City Plan Commission Agenda
May 10, 2022
Reedsburg City Hall Council Chambers
5:15 PM

Reedsburg Plan Commission

SITE DIMENSION PLAN	CONVENIENCE STORE #838	
	VIKING DRIVE & MAIN STREET REEDSBURG, WI	
#	DATE	DESCRIPTION
-		
-		
-		
-		
-		
-		
-		
-		
-		
DRAWN BY	IGRE	
SCALE	AS SHOWN	
PROJ. NO.	210374	
DATE	2022-04-19	
SHEET		
SP1

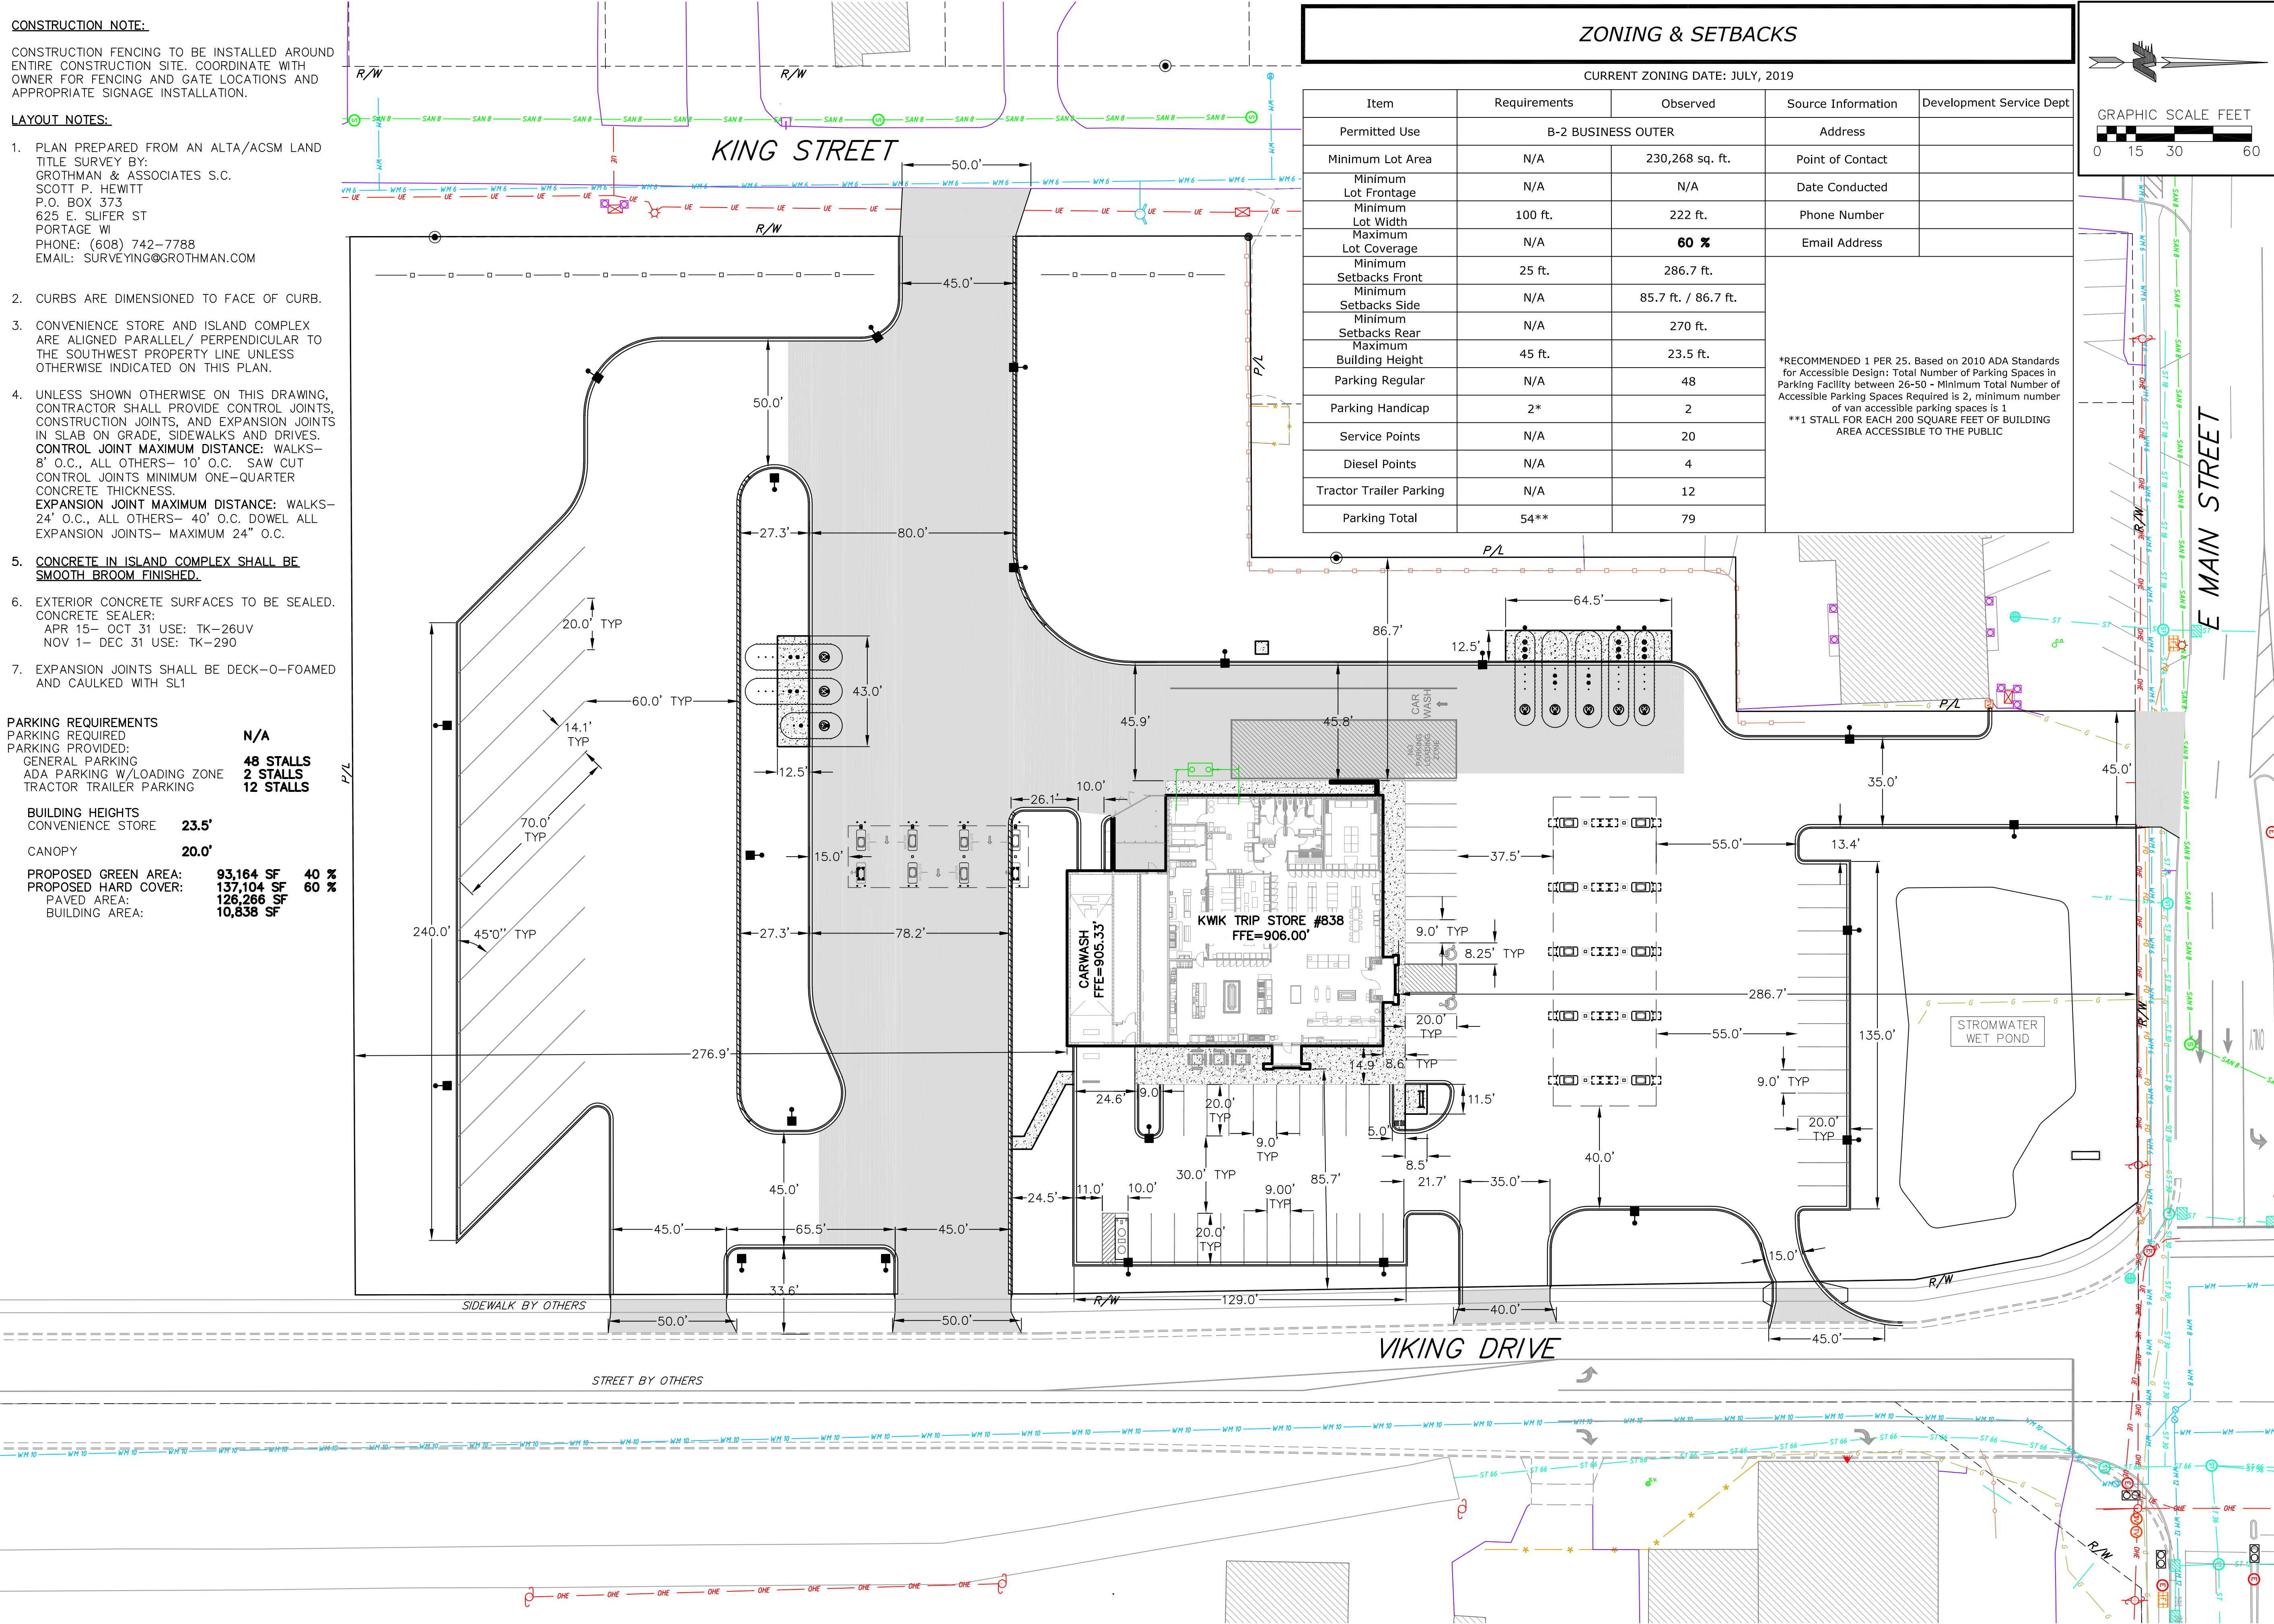
STAFF COMMENTS: The signage exceeds the ordinance but will be reviewed by the Zoning Board of Appeals this month. Two of the Viking Dr & King St driveways exceed the 35' limit, but the Plan Commission can approve larger curb cuts based on hardship (e.g. truck traffic).
